Appendix A

Comments and Responses

This appendix contains agency and public comments received on the SH 82/Grand Avenue Bridge Environmental Assessment during the 60-day comment period (October 31, 2014 through December 31, 2014). Agency comments are presented first, followed by public comments received at the November 19, 2014 public hearing (including verbal and written comments), and other written public comments received during the comment period. Note that letters to the editor printed in local newspapers were not considered comments submitted on the Environmental Assessment (EA), unless the letter was also submitted to the Colorado Department of Transportation (CDOT) as official comment on the EA. Responses are provided beside each comment.

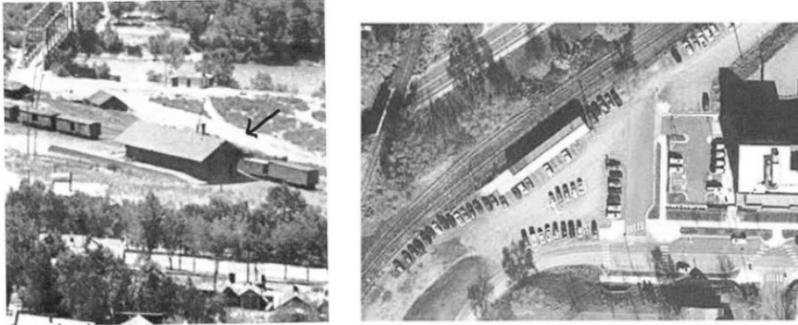
5ea	3-11 The EA should address the visual impact of the 25 foot tall retaining walls, and the impact of walls that are 562 feet in length. Walls that are located within public or pedestrian areas need to include treatments that add shadows and that have some visual interest. Long expanses of flat, mono-colored walls should not be acceptable as they are uninteresting and will become a magnet for graffiti. Form liners and sand blasted walls as suggested on page 3-22 should not be part of this project.	Please refer to Figure 3-6 of the EA that presents the aesthetic treatments for retaining walls currently being evaluated with the City and other stakeholders. CDOT is committed to including aesthetic treatments in retaining walls to mitigate their visual impact. Aesthetic treatments for retaining walls vary based on their location and setting. Please refer to Section 4.1 of the FONSI for more information.
